# Bobcat/Bunton Information Bulletin

**Bulletin No: C-010-04**

## **Kawasaki FH680V/FH721V Remote Engine Air Filter**

### Heavy Duty Canister Air Filter Intake Pipe Modification (FH 601V, 641V, 680V, 721V)

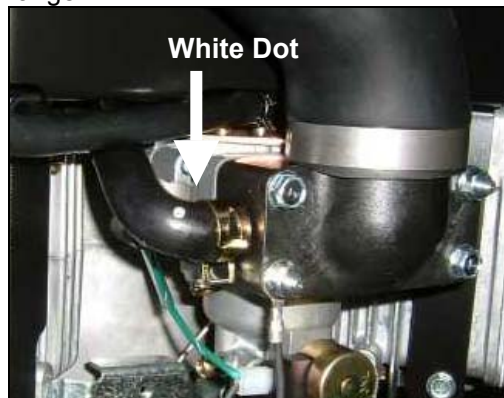
Sealing area between the intake pipe and carburetor is deformed.

Kawasaki has reinforced the intake pipe and added a bead on the gasket. Kawasaki has also reworked engines in inventory and initiated a Factory Directed Modification (FDM) campaign to repair eligible field units. Each machine manufacture will notify end users of this campaign and direct them to an authorized dealer for repair.

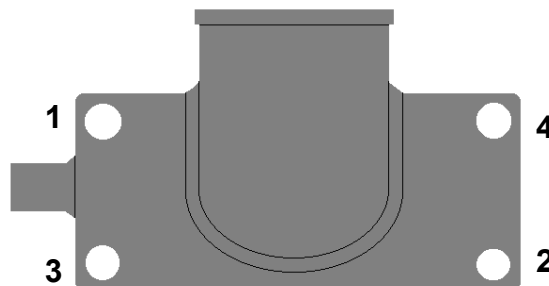
Repair all eligible units that have a heavy-duty canister air filter by installing a new reinforced plastic intake pipe and beaded gasket.

**Bolt Torque Specs: 4.3-5.7 ft/lbs.**

**Make sure to follow bolt torque pattern.**

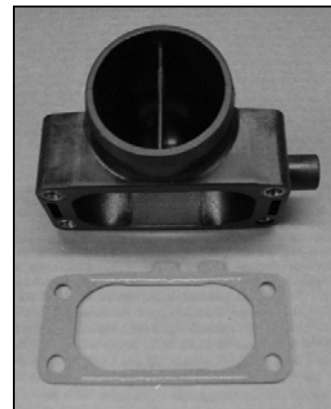
Kit contains intake pipe and beaded gasket.

Gasket should be installed with the tab down.
